Volt V2.820.0000000.5.R.210705

Release Notes

1.4.1 Algorithm Optimization for Big-animal False Alarm Based on SMD Function

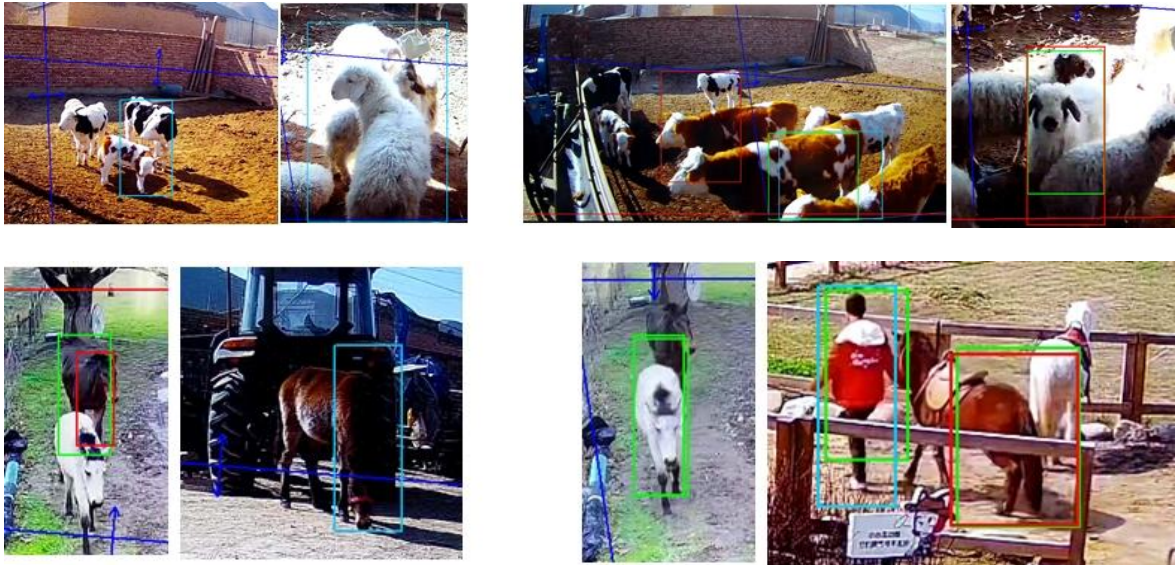
Through the optimization of the algorithm detection model, the SMD function is optimized for the released products, and the detection optimization is mainly for the large animal (such as cattle, horse, and sheep). The main optimization points are as follows:

The current SMD function only detects people and vehicles. Version 2.0 optimizes the false alarm of small animals, such as cats and dogs in the family. Version 3.0 optimizes the algorithm for large outdoor animals and trains massive animal data. If an animal trips the rule line, SMD will filter out the alarm triggered by animals and only keep the alarm triggered by people and vehicles.

The following false alarm will be filtered out:

1.4.2 AI Codc

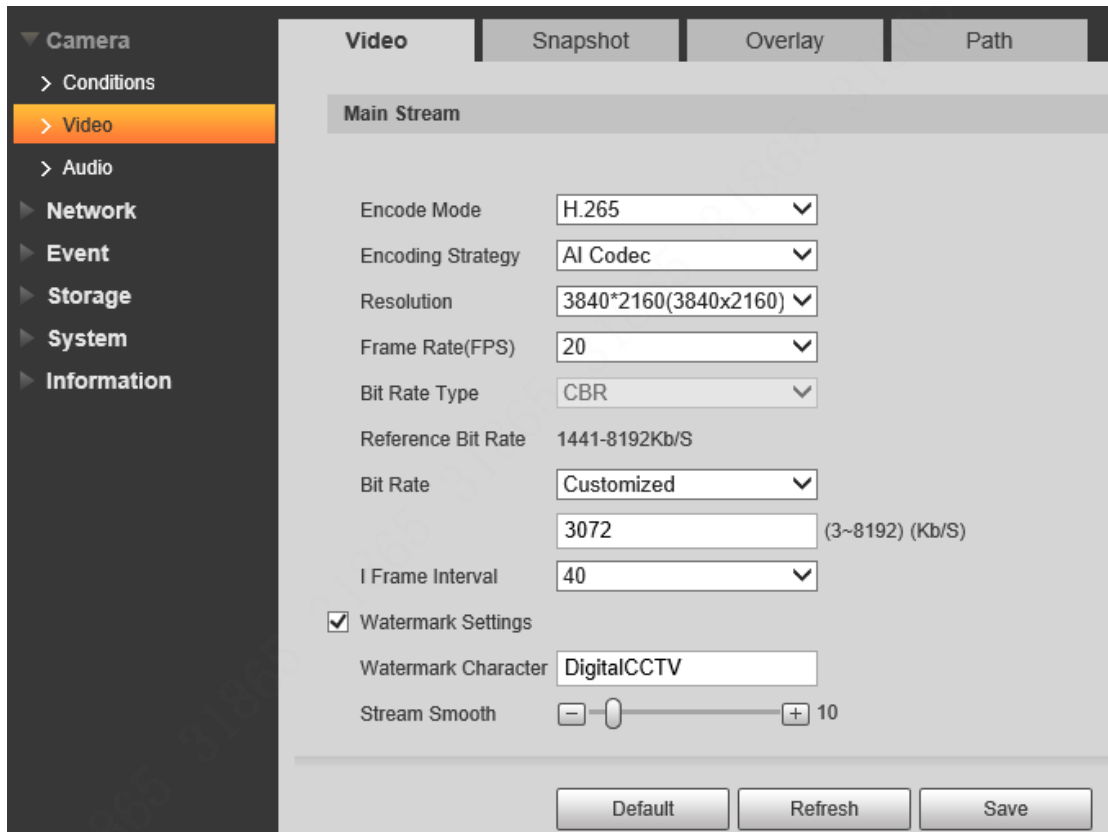
- AI codec mode is added to the main stream interface. You can select the encoding strategy as **General**, **Smart Codec**, and **AI Codec**.
- When selecting **AI Codec**, the bit rate type automatically switches to **CBR**, and the bit rate decreases by 25% compared to General mode.
- When selecting **AI Codec**, you can select frame rate as 1x or 2x under **I frame interval** list. It is 2x by default.
- The AI Codec mode is only added for devices with AI functions.
